PARTIAL SITE ELECTRICAL PLAN - POWER

MODERNIZATION AT CURRAN MIDDLE SCHOOL FOR:

PARTIAL SITE ELECT. PLAN - POWER

SHEET IDENTIFICATION NUMBER
ADD-007
E-112
SHEET OF

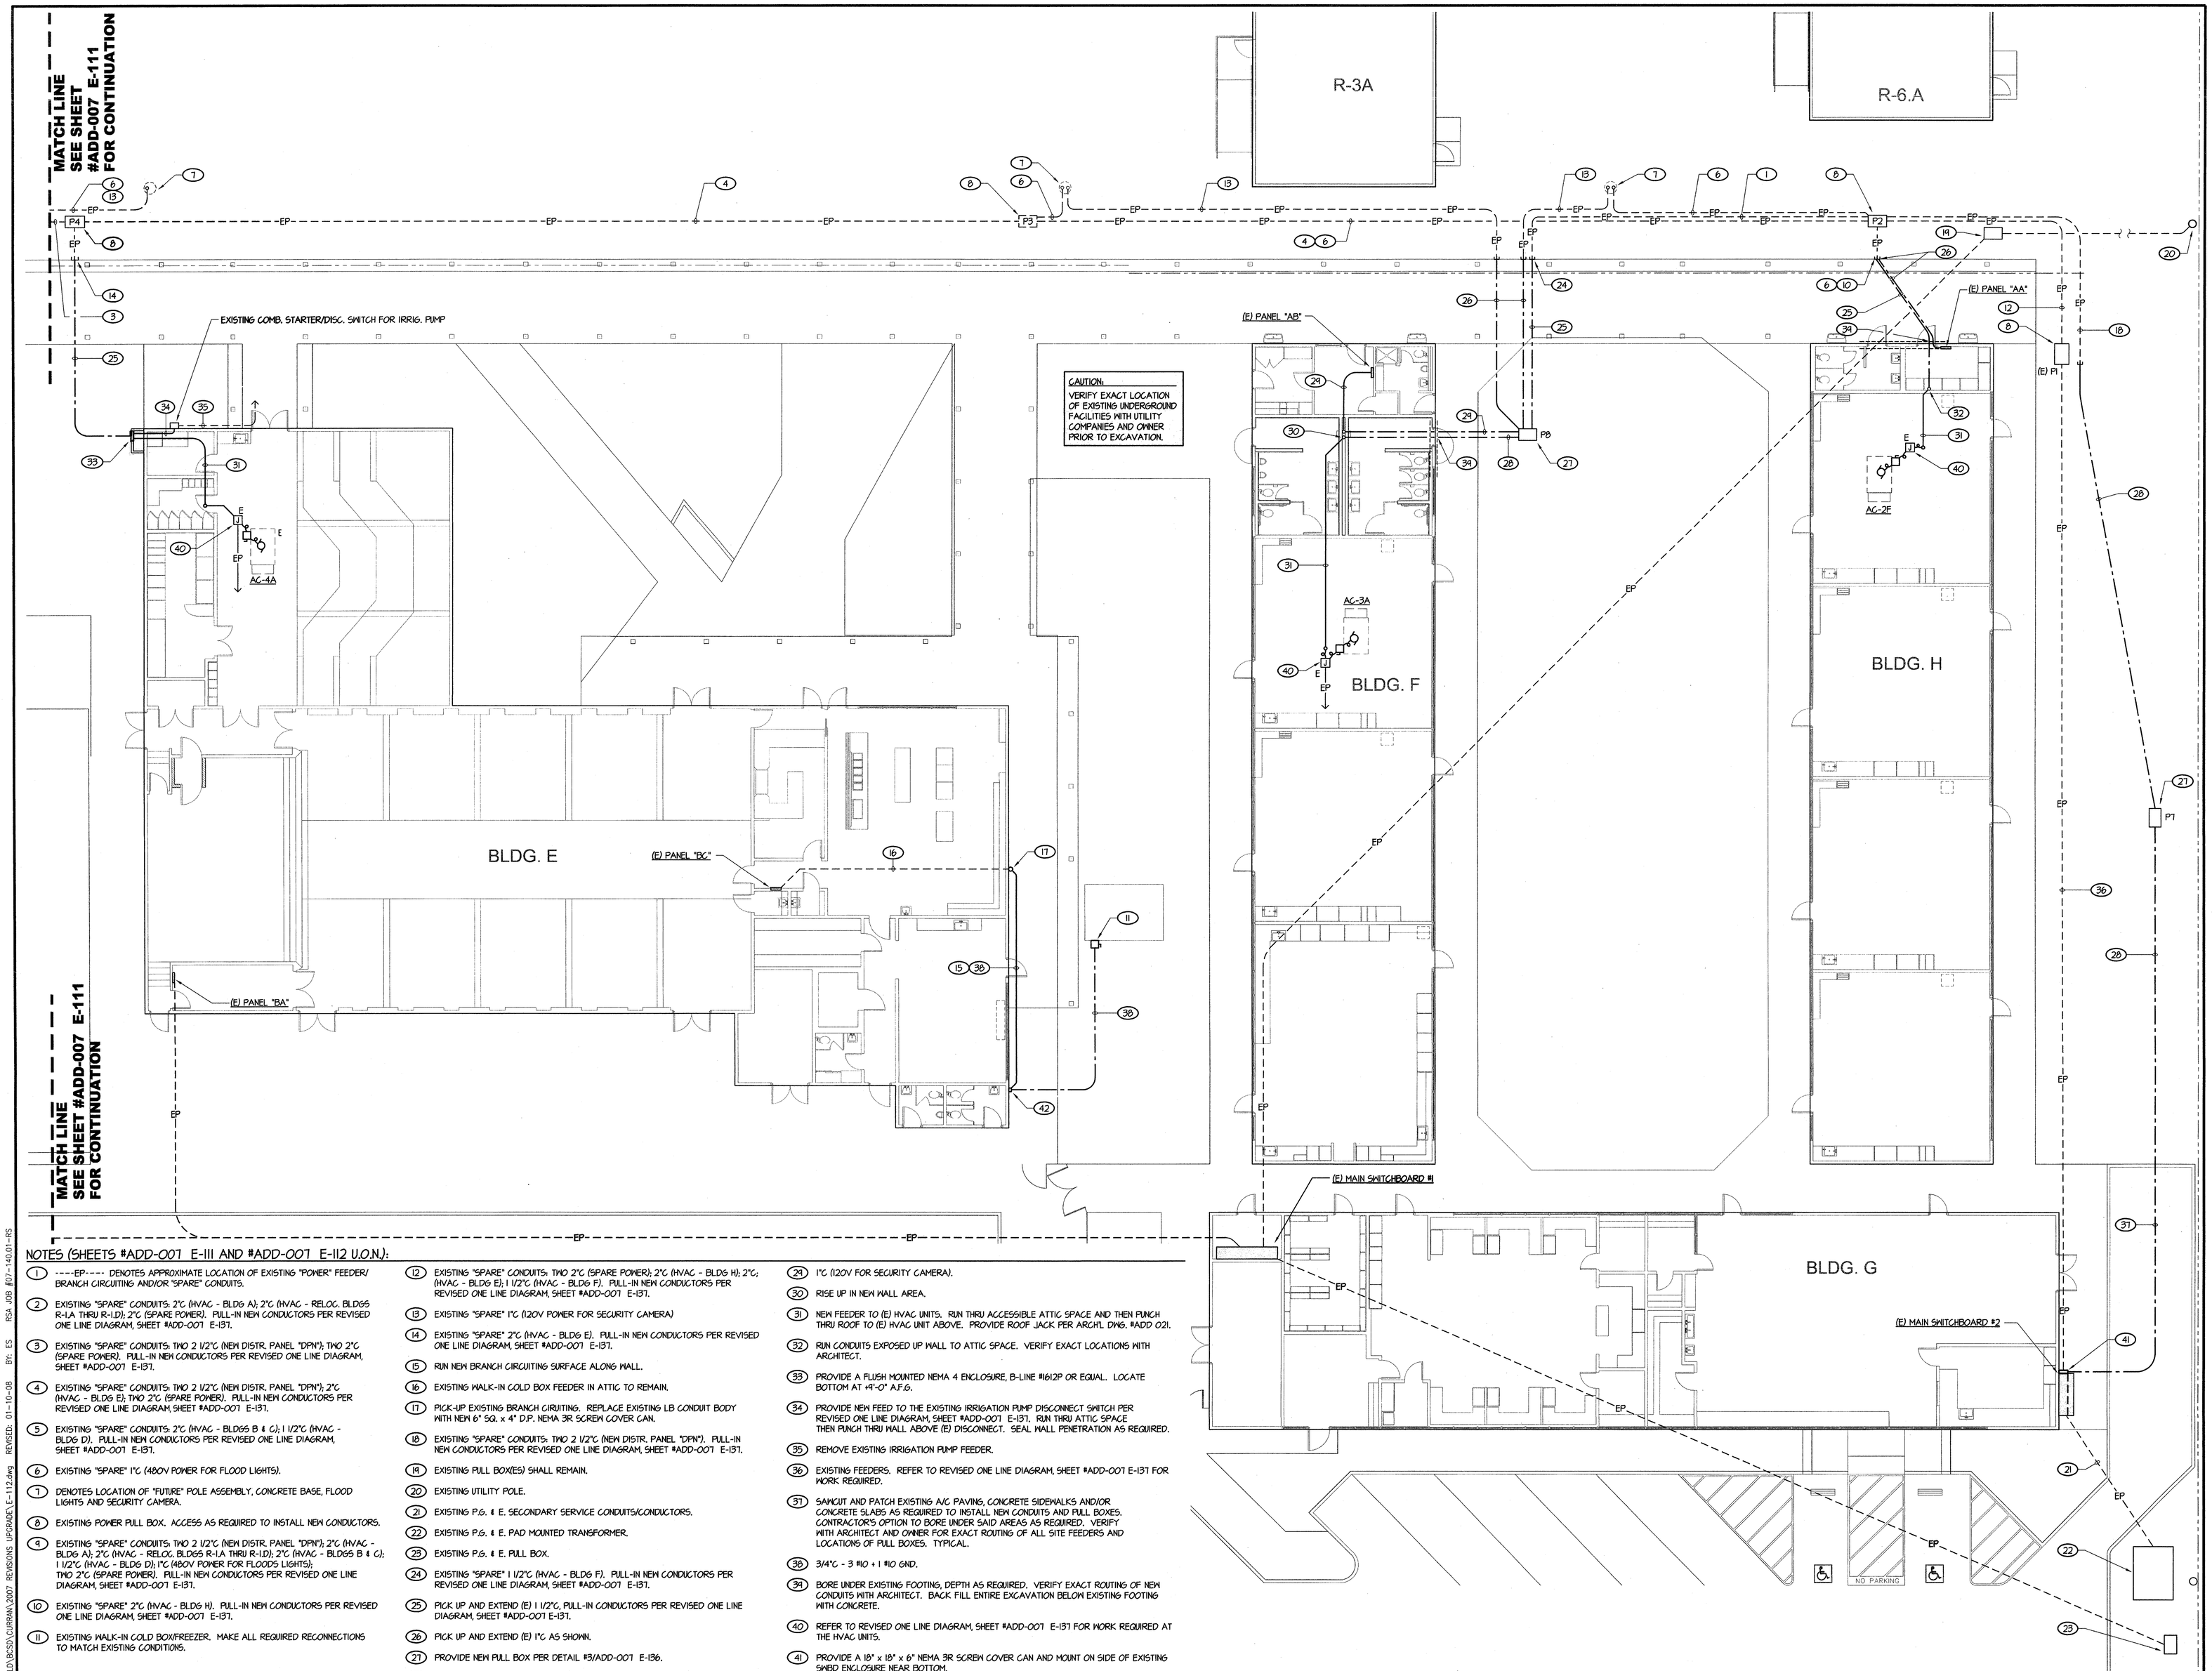
1. ----EP---- DENOTES APPROXIMATE LOCATION OF EXISTING "POWER" FEEDER/ BRANCH CIRCUITING AND/OR "SPARE" CONDUITS.
2. EXISTING "SPARE" CONDUITS: 2"C (HVAC - BLDG A); 2"C (HVAC - RELOC. BLDGS R-1A THRU R-1.D); 2"C (SPARE POWER). PULL-IN NEW CONDUCTORS PER REVISED ONE LINE DIAGRAM, SHEET #ADD-007 E-131.

3. EXISTING "SPARE" CONDUITS: TWO 2 1/2"C (NEW DISTR. PANEL "DPN"); TWO 2"C (SPARE POWER). PULL-IN NEW CONDUCTORS PER REVISED ONE LINE DIAGRAM, SHEET #ADD-007 E-131.

4. EXISTING "SPARE" CONDUITS: TWO 2 1/2"C (NEW DISTR. PANEL "DPN"); 2"C (HVAC - BLDG E); TWO 2"C (SPARE POWER). PULL-IN NEW CONDUCTORS PER REVISED ONE LINE DIAGRAM, SHEET #ADD-007 E-131.

5. EXISTING "SPARE" CONDUITS: 2"C (HVAC - BLDGS B & C); 1 1/2"C (HVAC - BLDG D). PULL-IN NEW CONDUCTORS PER REVISED ONE LINE DIAGRAM, SHEET #ADD-007 E-131.

9. EXISTING "SPARE" CONDUITS: TWO 2 1/2"C (NEW DISTR. PANEL "DPN"); 2"C (HVAC - BLDG A); 2"C (HVAC - RELOC. BLDGS R-1A THRU R-1.D); 2"C (HVAC - BLDGS B & C); 1 1/2"C (HVAC - BLDG D); 1"C (480V POWER FOR FLOODS LIGHTS); TWO 2"C (SPARE POWER). PULL-IN NEW CONDUCTORS PER REVISED ONE LINE DIAGRAM, SHEET #ADD-007 E-131.

12. EXISTING "SPARE" CONDUITS: TWO 2"C (SPARE POWER); 2"C (HVAC - BLDG H); 2"C; (HVAC - BLDG E); 1 1/2"C (HVAC - BLDG F). PULL-IN NEW CONDUCTORS PER REVISED ONE LINE DIAGRAM, SHEET #ADD-007 E-131.

24. EXISTING "SPARE" 1 1/2"C (HVAC - BLDG F). PULL-IN NEW CONDUCTORS PER REVISED ONE LINE DIAGRAM, SHEET #ADD-007 E-131.
25. PICK UP AND EXTEND (E) 1 1/2"C, PULL-IN CONDUCTORS PER REVISED ONE LINE DIAGRAM, SHEET #ADD-007 E-131.

26. PICK UP AND EXTEND (E) 1"C AS SHOWN.
27. PROVIDE NEW PULL BOX PER DETAIL #3/ADD-007 E-136.
28. FEEDERS PER REVISED ONE LINE DIAGRAM, SHEET #ADD-007 E-131.

29. 1"C (120V FOR SECURITY CAMERA).
30. RISE UP IN NEW WALL AREA.
31. NEW FEEDER TO (E) HVAC UNITS. RUN THRU ACCESSIBLE ATTIC SPACE AND THEN PUNCH THRU ROOF TO (E) HVAC UNIT ABOVE. PROVIDE ROOF JACK PER ARCHI. DWG. #ADD 021.

32. RUN CONDUITS EXPOSED UP WALL TO ATTIC SPACE. VERIFY EXACT LOCATIONS WITH ARCHITECT.
33. PROVIDE A FLUSH MOUNTED NEMA 4 ENCLOSURE, B-LINE #1612P OR EQUAL. LOCATE BOTTOM AT +9'-0" A.F.G.

34. PROVIDE NEW FEED TO THE EXISTING IRRIGATION PUMP DISCONNECT SWITCH PER REVISED ONE LINE DIAGRAM, SHEET #ADD-007 E-131. RUN THRU ATTIC SPACE THEN PUNCH THRU WALL ABOVE (E) DISCONNECT. SEAL WALL PENETRATION AS REQUIRED.

35. REMOVE EXISTING IRRIGATION PUMP FEEDER.
36. EXISTING FEEDERS. REFER TO REVISED ONE LINE DIAGRAM, SHEET #ADD-007 E-131 FOR WORK REQUIRED.
37. SAWCUT AND PATCH EXISTING A/C PAVING, CONCRETE SIDEWALKS AND/OR CONCRETE SLABS AS REQUIRED TO INSTALL NEW CONDUITS AND PULL BOXES. CONTRACTOR'S OPTION TO BORE UNDER SAID AREAS AS REQUIRED. VERIFY WITH ARCHITECT AND OWNER FOR EXACT ROUTING OF ALL SITE FEEDERS AND LOCATIONS OF PULL BOXES. TYPICAL.

38. 3/4"C - 3 #10 + 1 #10 GND.
39. BORE UNDER EXISTING FOOTING, DEPTH AS REQUIRED. VERIFY EXACT ROUTING OF NEW CONDUITS WITH ARCHITECT. BACK FILL ENTIRE EXCAVATION BELOW EXISTING FOOTING WITH CONCRETE.

40. REFER TO REVISED ONE LINE DIAGRAM, SHEET #ADD-007 E-131 FOR WORK REQUIRED AT THE HVAC UNITS.
41. PROVIDE A 18" x 18" x 6" NEMA 3R SCREW COVER CAN AND MOUNT ON SIDE OF EXISTING SHED ENCLOSURE NEAR BOTTOM.

42. PROVIDE A 6" x 6" x 4" NEMA 3R SCREW COVER CAN AND MOUNT AT +9'-0" A.F.G.
